Draft: **ECE-R XXX**

Testing: Mechanical coupling devices for agricultural vehicles
Last updated: 21 July 2011

**Uniform Provisions Concerning the Approval of Mechanical Coupling Components for
Agricultural Vehicles**

Figure 1 – Vertical load in the latching

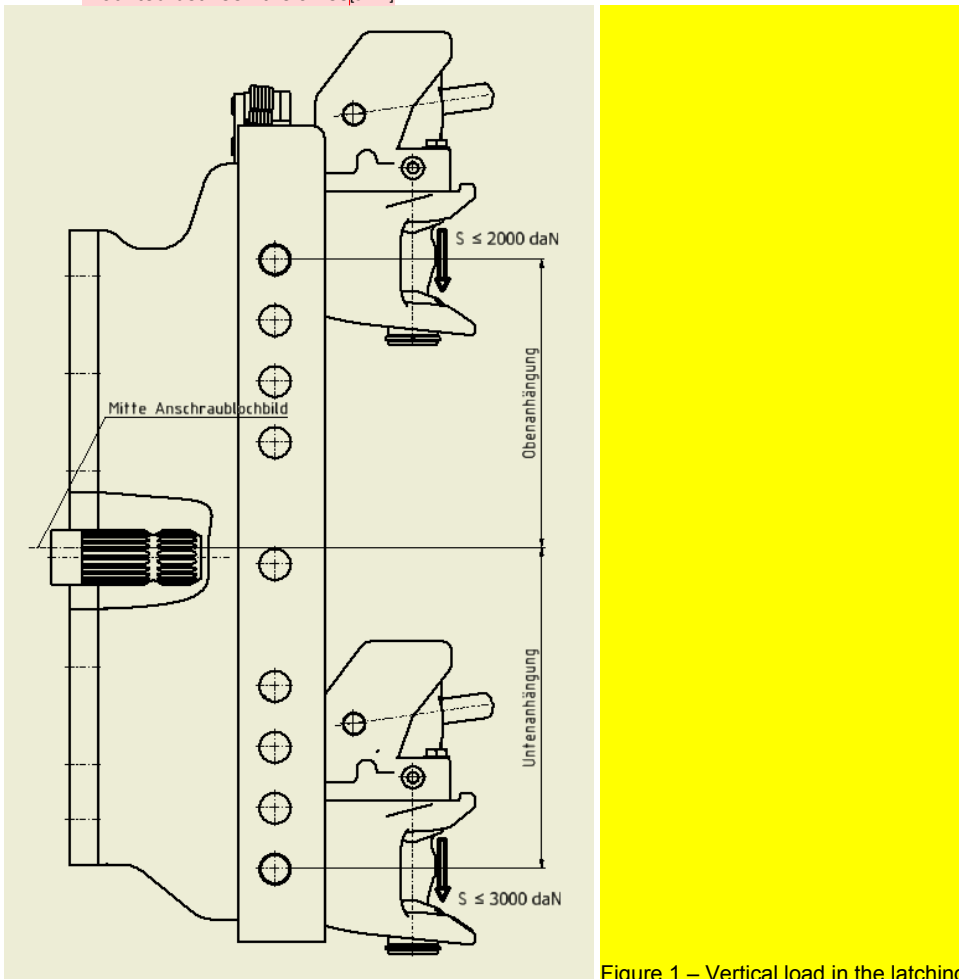
4.9 The maximum vertical load for coupling devices on the rear of a tractor may not exceed 4000 daN. Quick height-adjustable towing devices in the latching rail may not exceed 3000 daN. A maximum of 2000 daN is permissible above the centre of the drilling pattern for mounting or the power take-off. [SP13]
Vertical loads in excess of 4000 daN are only permissible for coupling devices which are mounted between the axles. [SP14].

Figure 19 – Principal dimensions of standard coupling ring d2-40

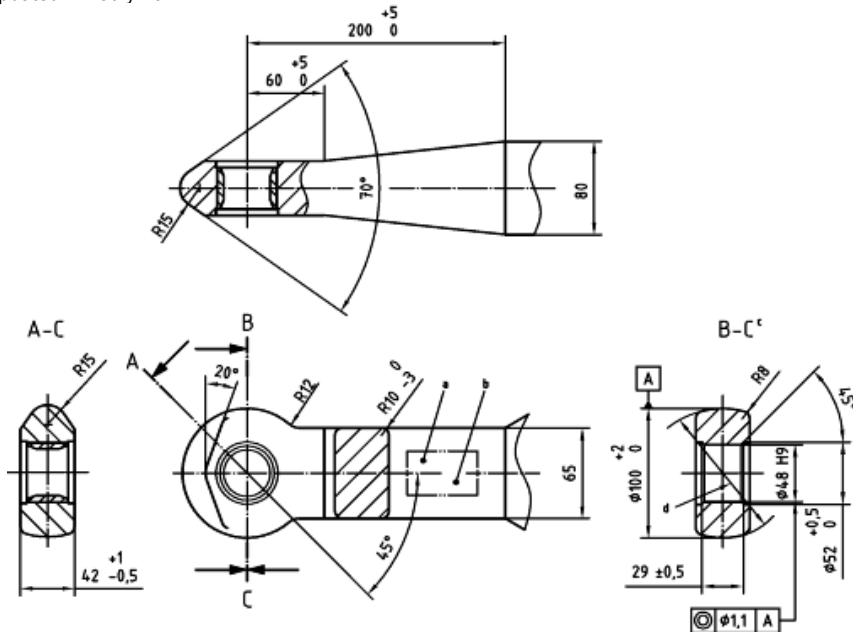
All coupling rings of Class d2-40 shall be designed so that they are able to satisfy the tests given in **xx** of annex 6. **This point is not present in annex 6!**

Figure 20 – Hitch ring 50

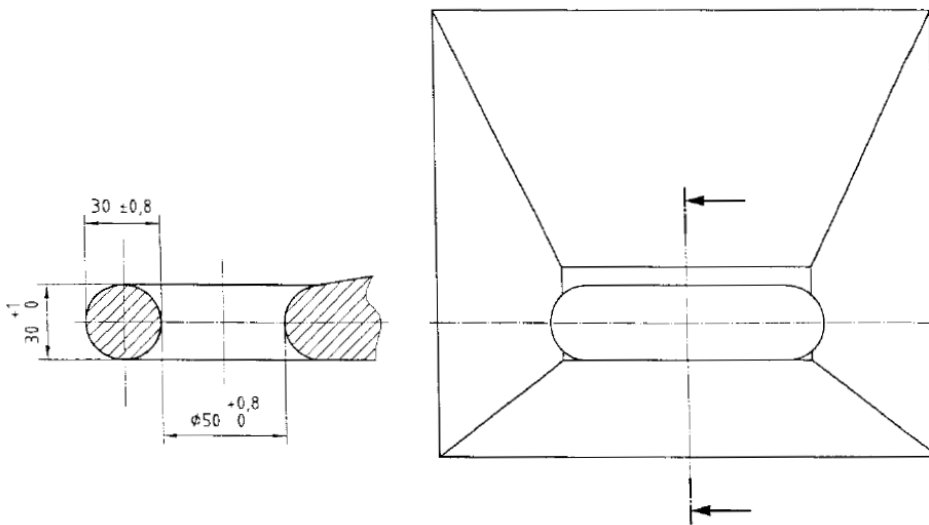
All coupling rings of Class d3 shall be designed so that they are able to satisfy the tests given in **xx** of annex 6. **There is no point for d3.**

Coupling rings of Class d3 shall conform to Figure **xx** in external shape and external dimensions.

Figure 22 –

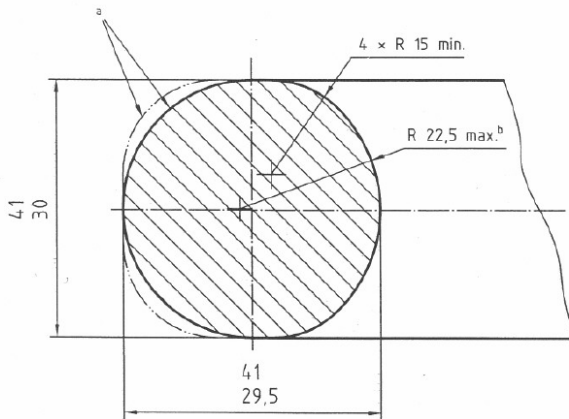
All coupling rings of Class d4 shall be designed so that they are able to satisfy the tests given in **xx** of annex 6. **There is no point for d4**

Coupling rings of Class d4 shall conform to Figure **xx** in external shape and external dimensions.

[SP39] Figure 25 – Principal dimensions of the qha towing bracket. The abbreviation qha should be added to the list of abbreviations.

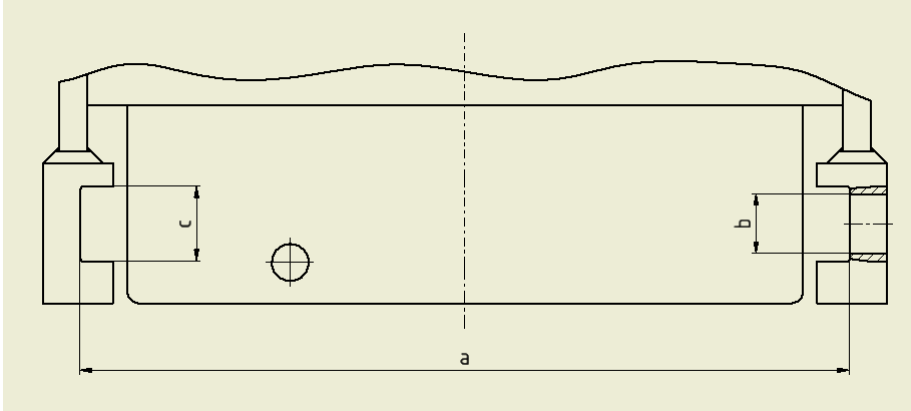
Towing brackets of Class f-1 shall be designed to prevent the latching rail plate from slipping.
Note: numbering is missing

Figure 27 – Principal dimensions of hitch hook

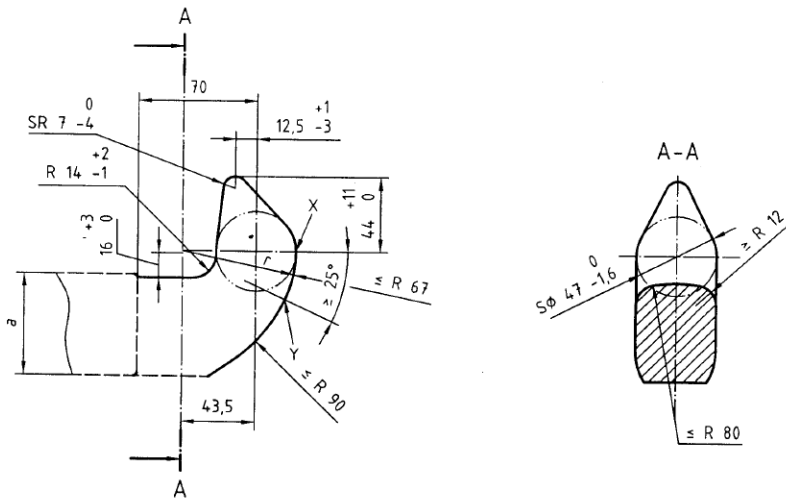
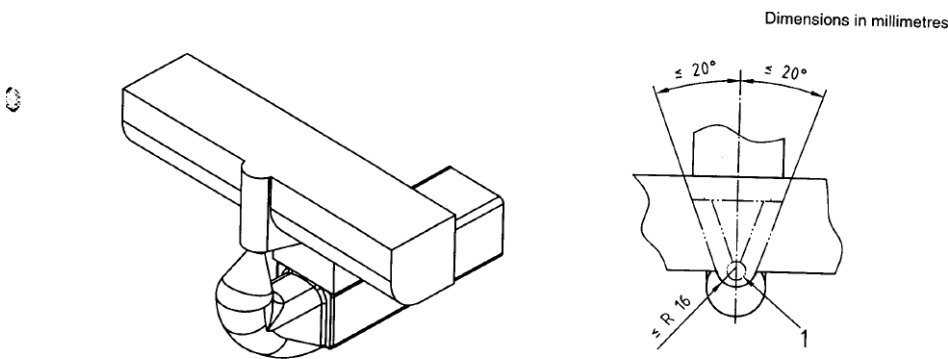
All hitch hooks and keeper plates shall be designed such that hitch hooks satisfy the tests given in xx3.3.2 of annex 6 and keeper plates satisfy the tests given in xx3.3.5 of annex 6.
